Conceptual Review Agenda

Schedule for 05/06/13 to 05/06/13

Re: Lot 20, Blk 3, Evergreen Park - Steel Fab. Shop/Self Storage

Description of project: This is a request to use Lot 20, Block 3 Replat Evergreen Park (Parcel # 97013-09-020) as a steel fabrication shop and self-storage facility. Two alternatives have been submitted, including utilizing the lot for both the steel shop and self storage, or utilizing the entire lot for only self-storage. The site is located in the Industrial (I) zone district. Industrial uses and mini-storage facilities are subject to Administrative (Type 1) review in the Industrial zone district.

Scotch Pines Site Plan Concept

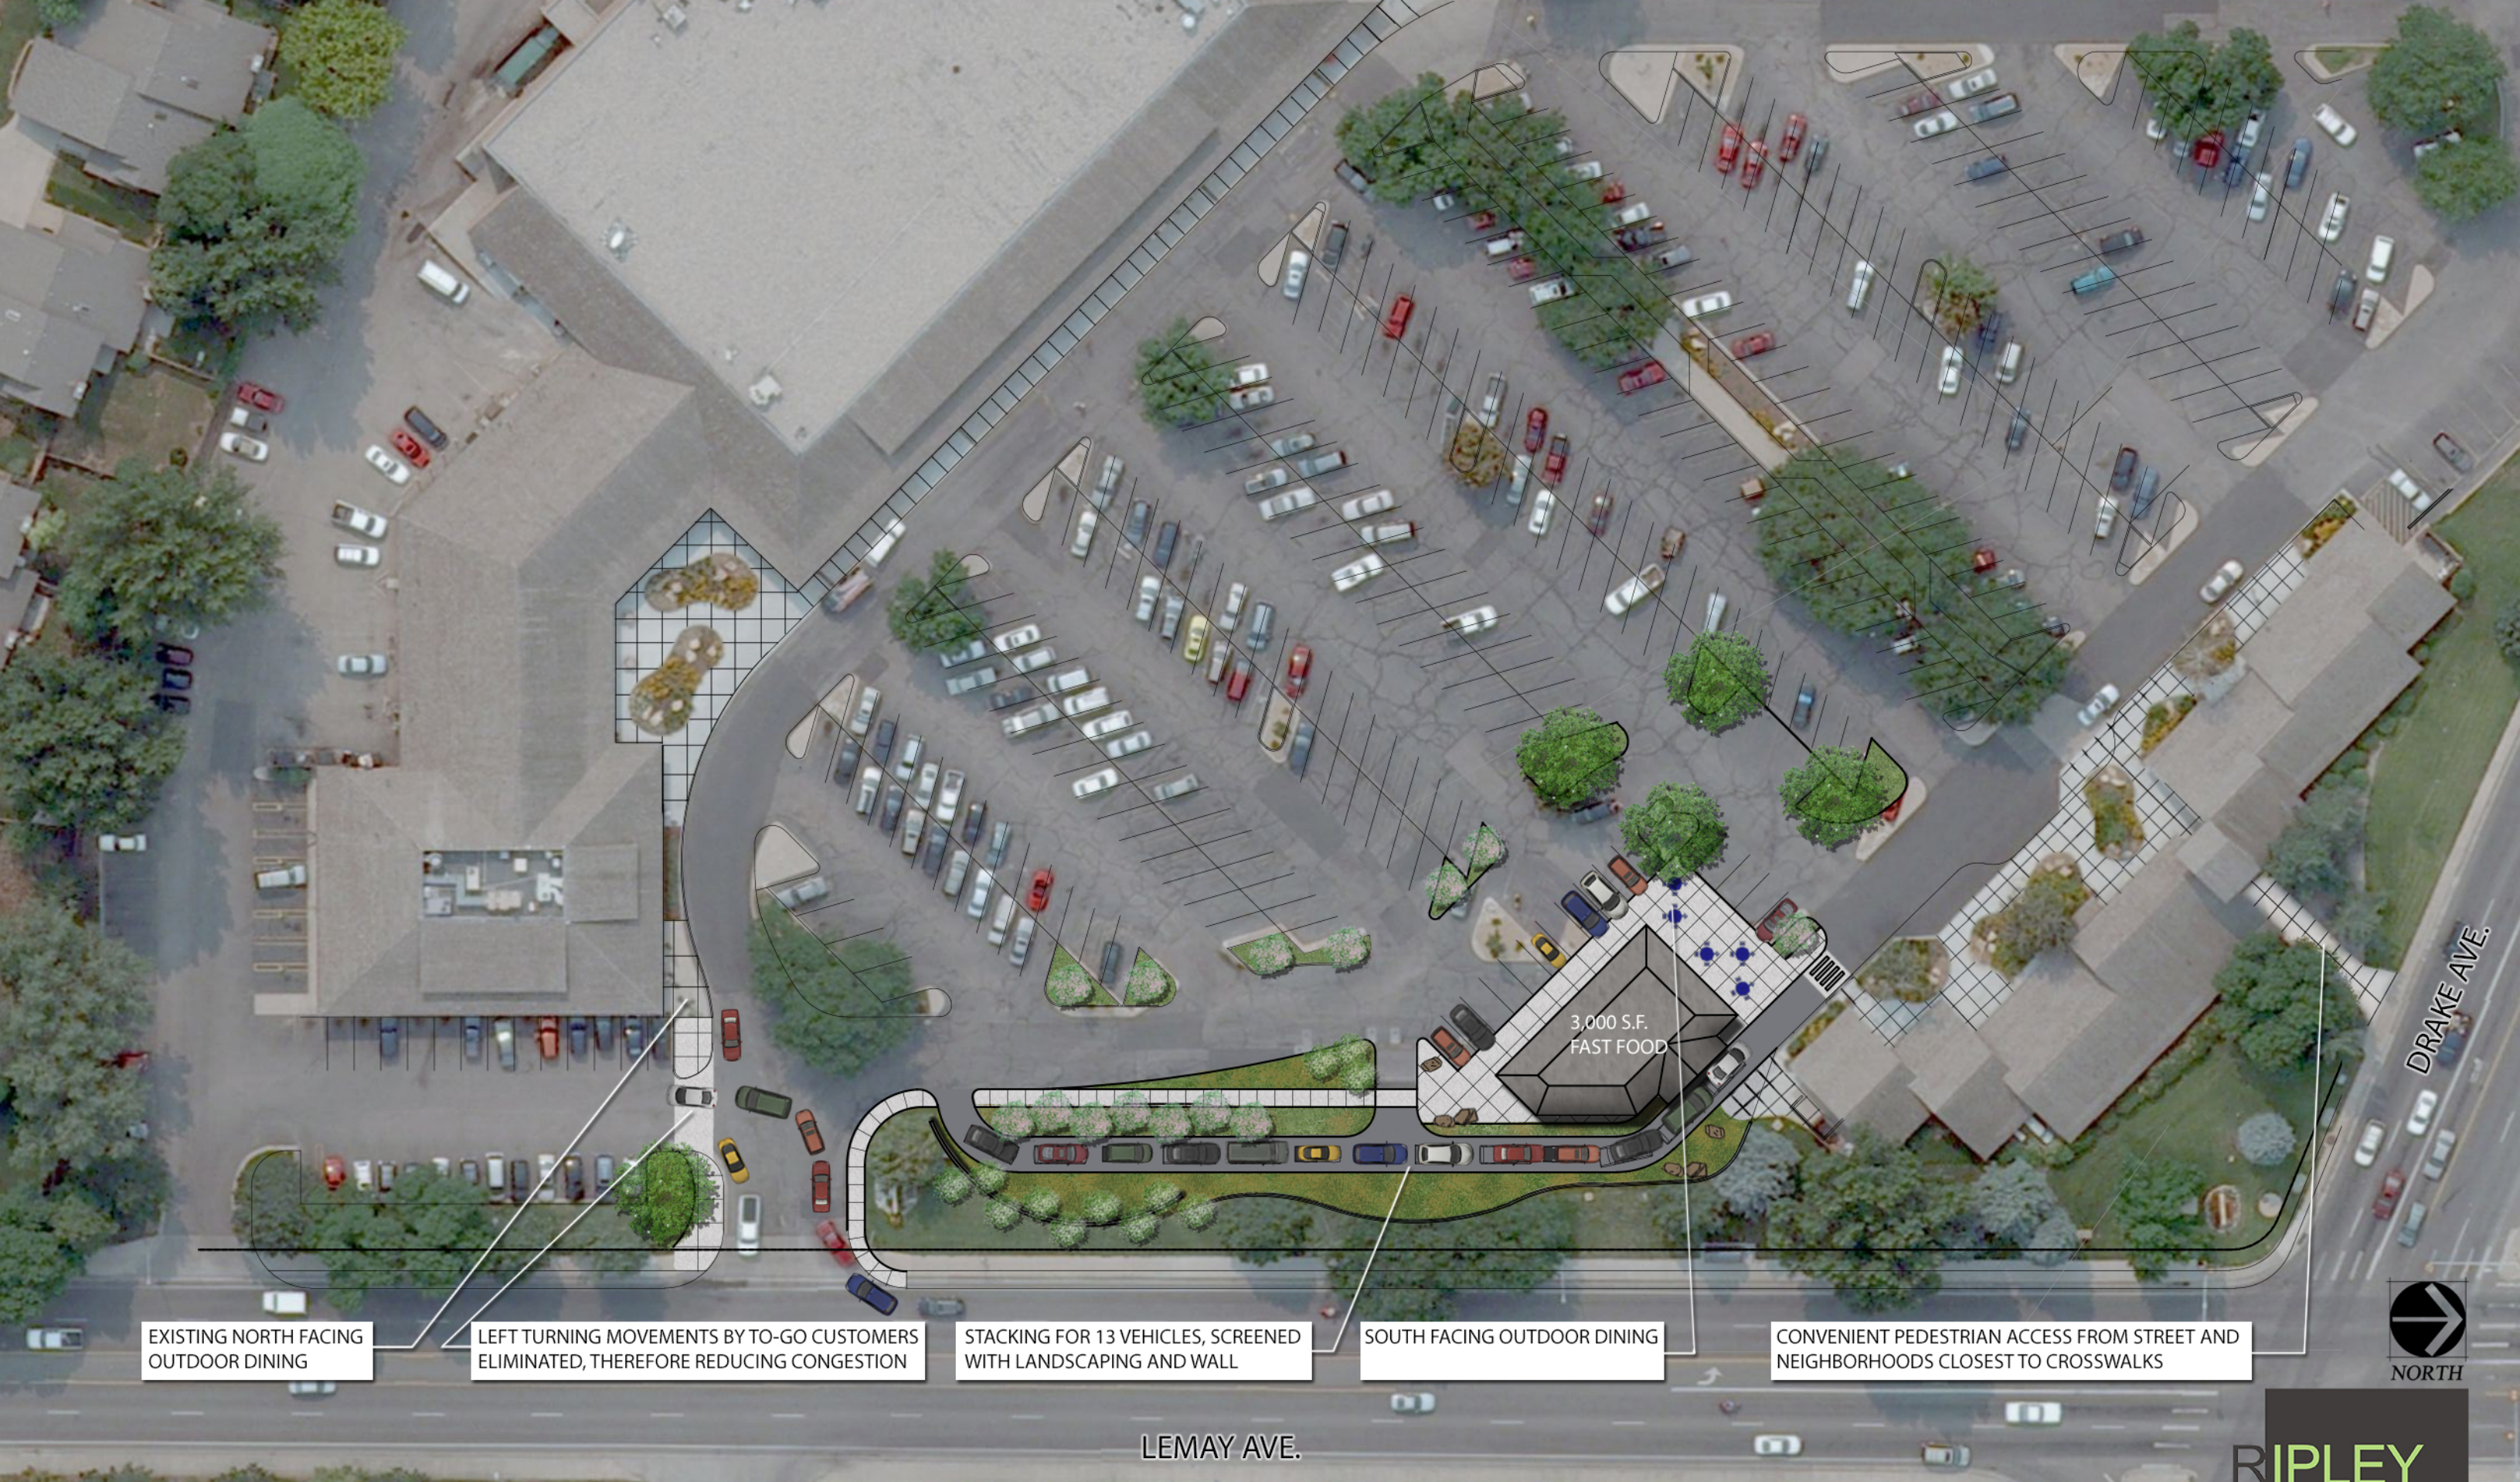
2. Please provide a chart with the submittal that demonstrates how the project meets or exceeds the landscape standards in 3.2.1(D) and (E).
3. The current project plan will require a Modification of Standard to 3.5.3(B)(2) addressing vehicle use areas between the building face and street, and to 3.5.3(B)(1) addressing connecting walkways.

4. The build-to line requirement is 10' minimum to 25' maximum. per 3.5.3(B)(2)(c).
5. The proposed addition of permitted use is subject to Section 1.3.4 Addition of Permitted Uses, of the LUC. The proposed use is subject to a Type 2 (Planning and Zoning Board) review and public hearing. The applicant for this development request will be required to hold a neighborhood information meeting prior to formal submittal of the project. Type 2 development proposals are subject to the neighborhood meeting requirement, per Section 2.2.2 of the LUC. Please contact me at 221-6750, to assist you in setting a date, time, and location for a meeting. A planner and possibly other City staff, would be present to facilitate the meeting.
